BAR Meeting
January 26, 2011

ISSUE: Partial Demolition and Addition

LOCATION: 927 Oronoco Street

**BAR CASE #2011-0002
#2011-0005**

1 PROPOSED EAST ELEVATION
 A1 SCALE: 1/4" = 1'-0"

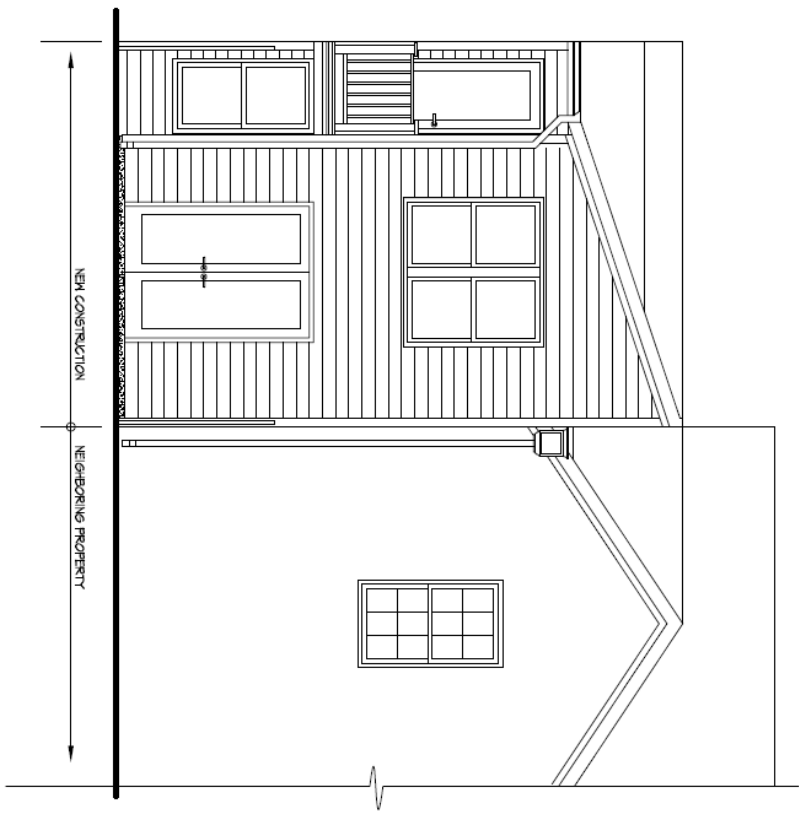
Staff is concerned with many of the proposed materials outlined for the project, as they are not typically approved by the BAR on historic or modern buildings within the historic district. These include the cellular PVC windows, fiberglass doors, and hollow-core composite railings. The vinyl composite decking proposed will not be visible from the public ROW and the fiberglass doors on the lower level will be only minimally visible over the wood fence along the public alley.

The applicant is proposing cellular PVC windows. Although Staff supports the use of an appropriate high-quality modern window materials, as long as they are compatible with the existing and surrounding buildings in the district, the newly adopted Window Policy specifically discourages the use of vinyl. Hollow, extruded vinyl windows such as these are particularly problematic because of their poor past performance and because their typical white shiny surface cannot be painted the wide variety of colors used on historic windows. The newly adopted Window Policy does, however, allow the use of high quality aluminum clad wood windows on new construction and additions. Therefore, Staff recommends that the Board support painted wood or aluminum clad 1/1 windows instead of the proposed cellular PVC.

The current proposal specifies that the balustrade is fabricated of a hollow-core composite product. The Board generally considers high-quality synthetic/composite materials to be solid-through-the-core, field paintable, milled similarly to wood, and to have a similar texture and feel to wood. Therefore, Staff finds the proposed use of the hollow-core PVC product not consistent with these policies and recommends that the applicant submit either a painted wood balustrade or a balustrade fabricated from a high-quality synthetic/composite solid-through-the-core, paintable material.

1. That cellular PVC windows on the addition are changed to be either painted wood or aluminum clad wood windows.
2. That the balustrades are fabricated out of wood or a paintable synthetic/composite solid-through-the-core high-quality material.

A1	BERGNER RESIDENCE - PROPOSED SIDE & REAR ELEVATIONS	 KULINSKIGROUP.COM 703.836.7243
	927 ORONOCO ST ALEXANDRIA, VA 22314 CITY OF ALEXANDRIA B.A.R. SUBMITTAL

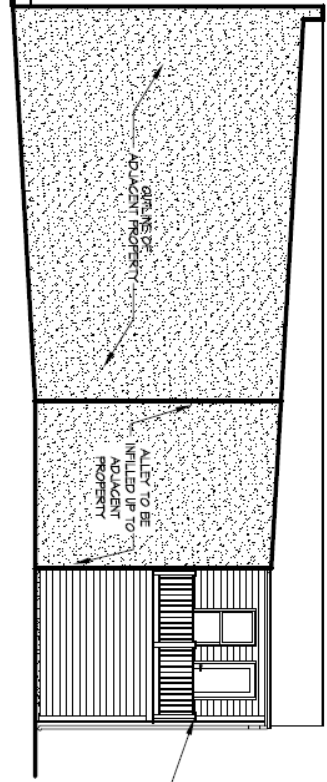
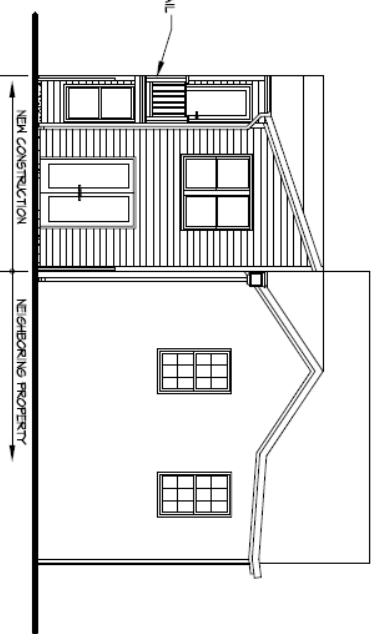
Staff has no objection to the proposed encapsulation and demolition of portions of the north (rear) elevation and finds the proposed addition and extension to be compatible with the existing building and surrounding area.

In the opinion of Staff, this early 20th century townhouse is historically significant to the overall historic district and compatible with the streetscape. Staff has no objection to the proposed demolition and encapsulation of portions of the rear walls and finds the proposed additions to be compatible with the existing building. The area proposed for demolition/encapsulation is located on a secondary elevation, does not remove any portion of the building containing character defining features of uncommon design or historic merit, and does not compromise the historic integrity of the building or the district as a whole. As such, Staff believes none of the criteria for demolition and encapsulation are met and the Permit to Demolish/Encapsulate should be granted.
